UNITED STATES
NUCLEAR REGULATORY COMMISSION

SUBJECT: DRAFT COPY OF PREAPPLICATION SAFETY EVALUATION REPORT (PSER) ON THE
MODULAR HIGH-TEMPERATURE GAS-COOLED REACTOR (MHTGR)

This preapplication safety evaluation report (PSER) documents the results of the preapplication review, from 1986 through the present, of the conceptual design of the Modular High-Temperature Gas-Cooled Reactor (MHTGR) design, Nuclear Regulatory Commission (NRC) Project No. 672. The Department of Energy (DOE), the preapplicant for the MHTGR design, submitted the advanced reactor design to NRC in response to the Commission's Advance Reactor Policy Statement (51 *Federal Register* 24643). This policy statement provides for the early NRC review and interaction with designers and preapplicants before the submittal of a design approval application for preliminary design approval, final design approval, or standard plant design certification under 10 CFR Part 52.

FIGURE 4.2
TRISO PARTICLE COATING FAILURES

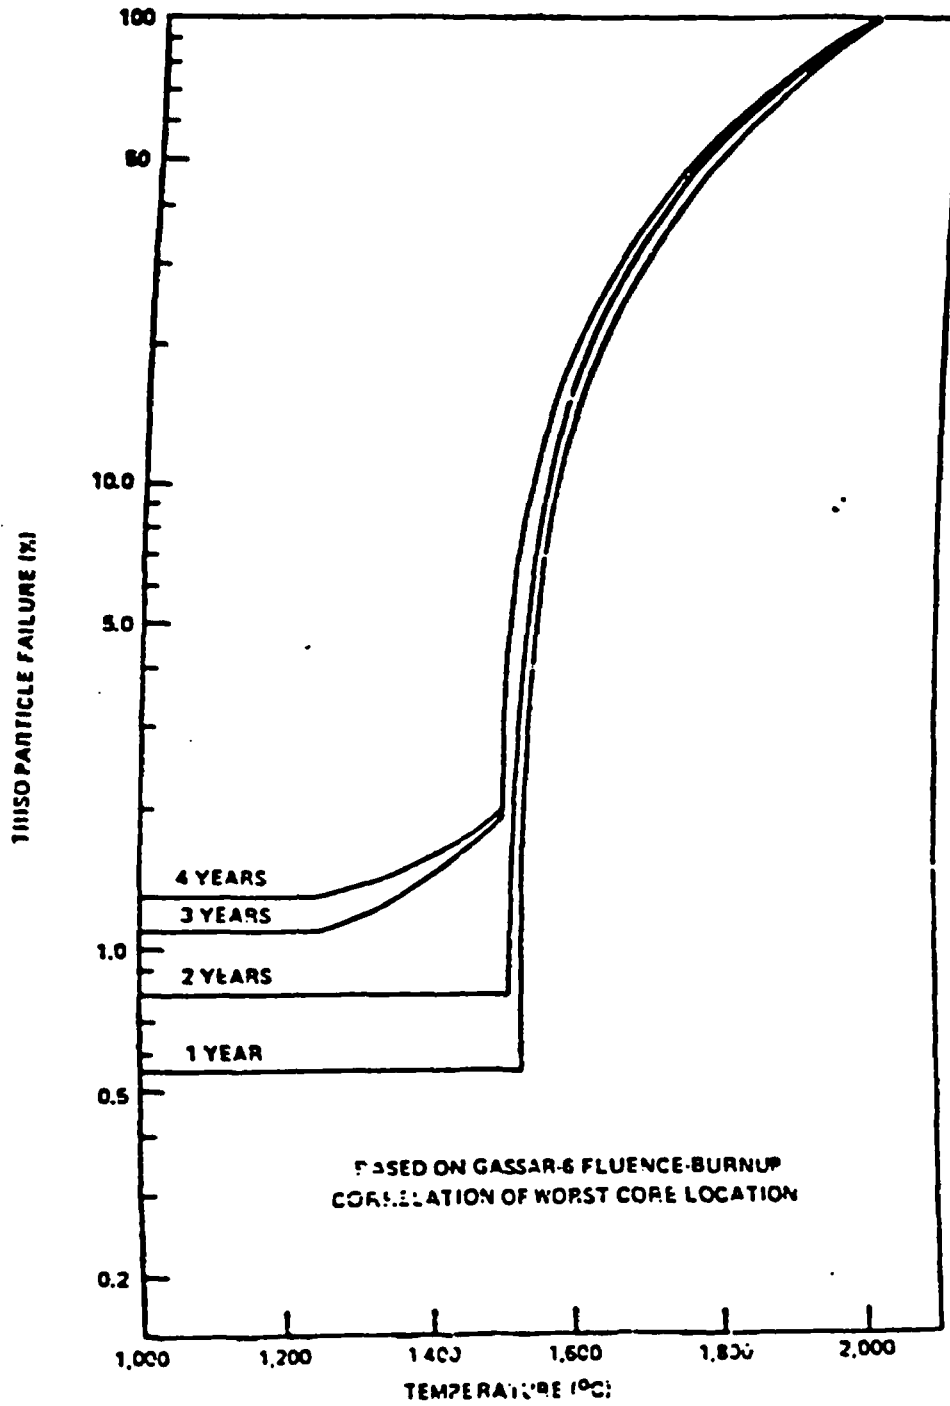
Figure 4.2 could be coupled with calculations of the temperature and neutron fluence of the core during an event to determine the number of failed fuel particles in the separate regions of the core and averaged over the entire core to determine the failed fuel fraction for the core. The fraction of defective fuel in the core would be based on the fraction of the core which exceeded 1600 °C (2900 °F) and the annualized neutron fluence of the fuel particles. The time to failure would be based on the temperature rise in the delay-heatup of the core following an accident. The staff reported in NUREG-0111 Chapter V that the core-averaged failed-fuel fraction was 0.268 percent for the GASSAR standard HTGR plant, which is a significantly higher failed-fuel-fraction value than DOE has proposed for the MHTGR.
